Additional Agency Correspondence

Subject: Requesting Comments on Flickertail Solar Vegetation Management Plan

RE: Case No. PU-24-351 - Proposed Flickertail Solar Project, Richland County, ND

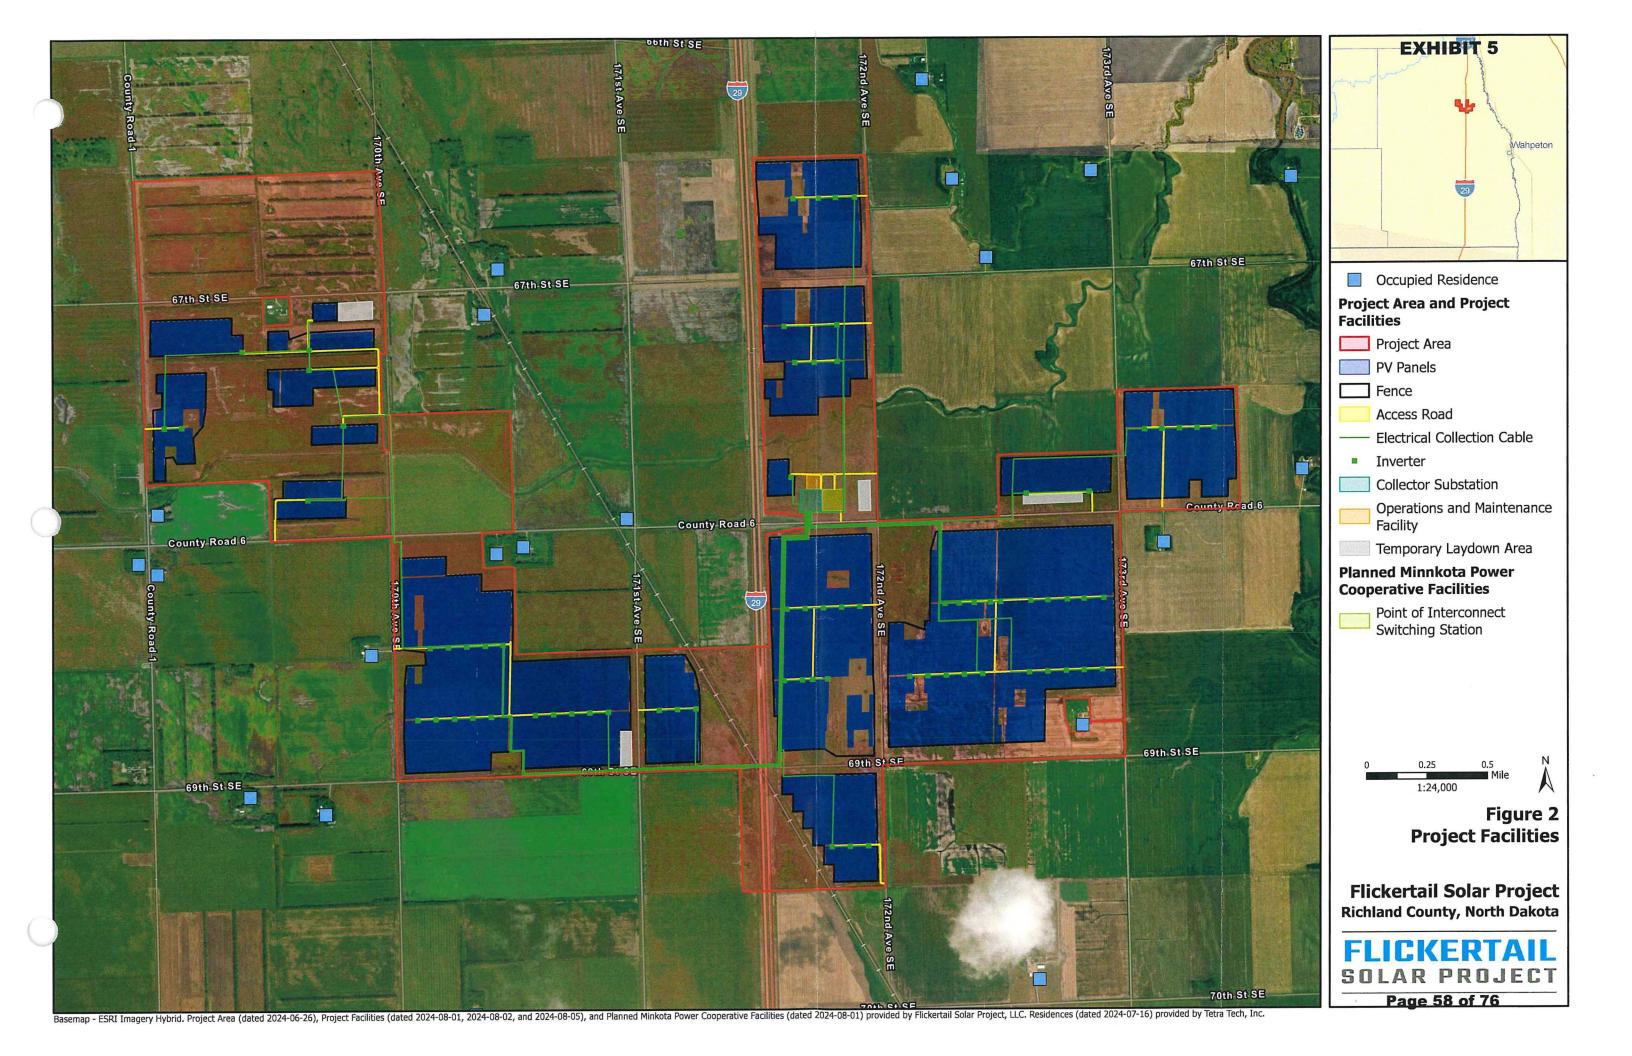
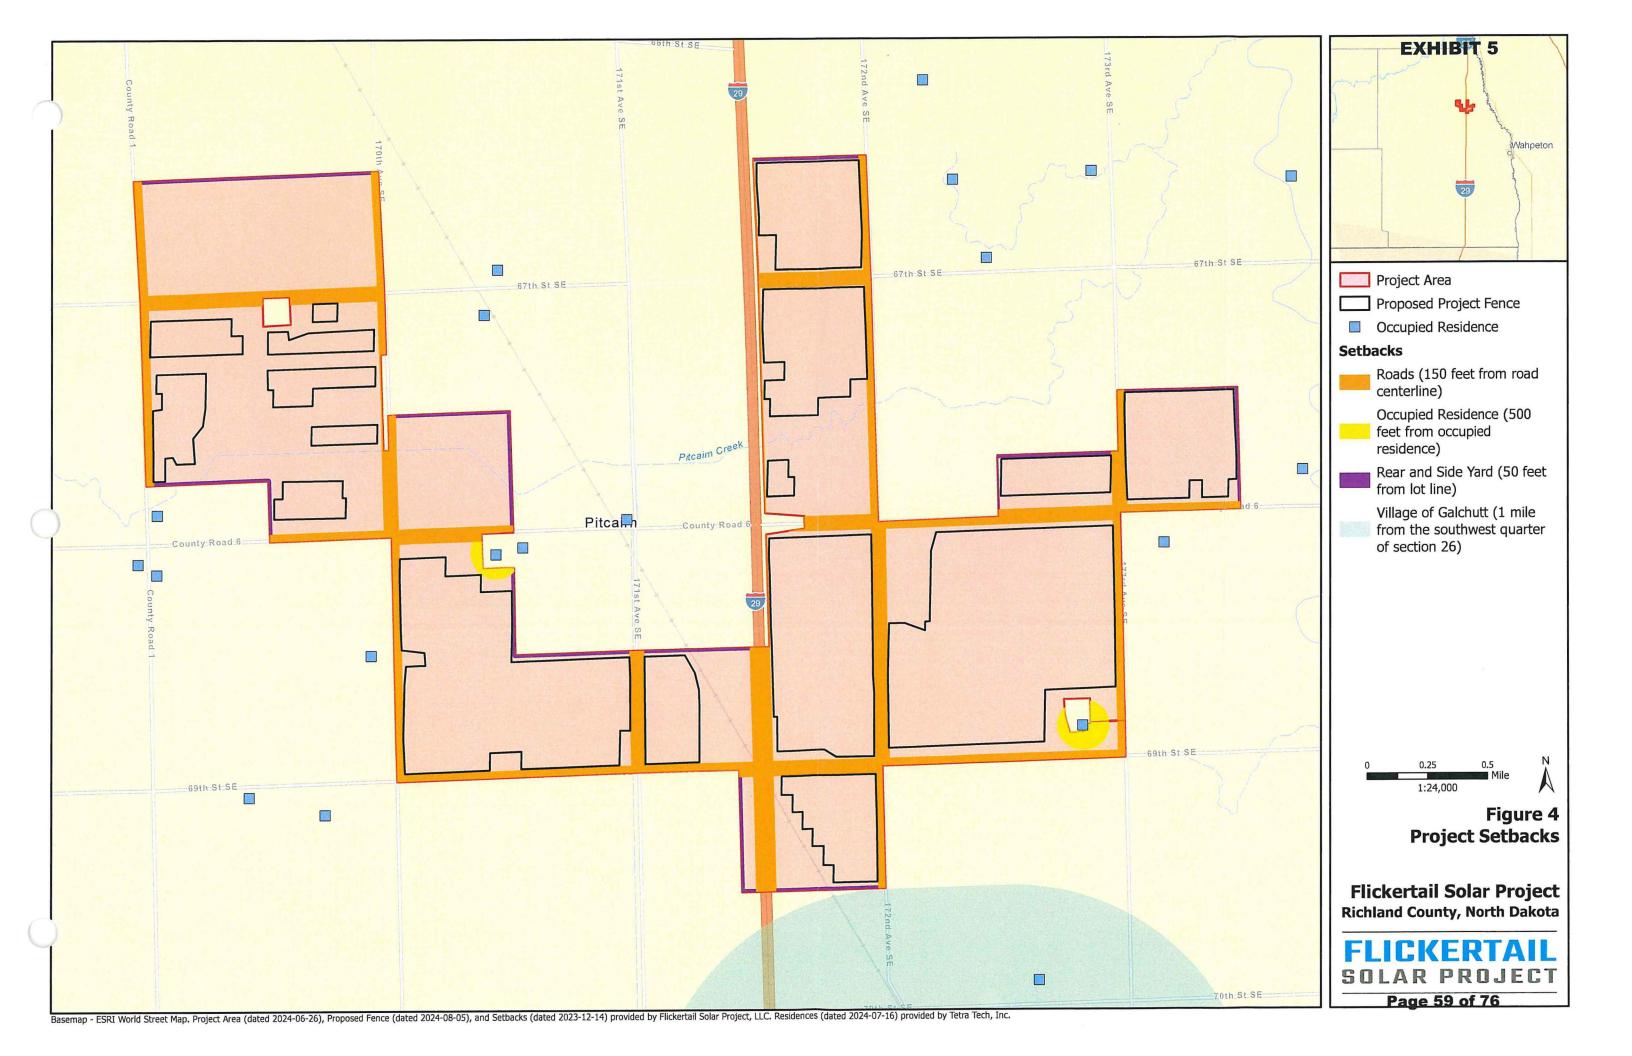
One thing to note is that the Project Area is not the extent of the above-ground Project facilities. The attached map was submitted to the PSC as part of the application and shows the extent of the proposed panels, fences, O&M facility, and substations. Per Abercrombie Township setbacks (Fig 4), all solar facilities need to be at least 150 feet from the road centerlines and at least 500 foot from residences.
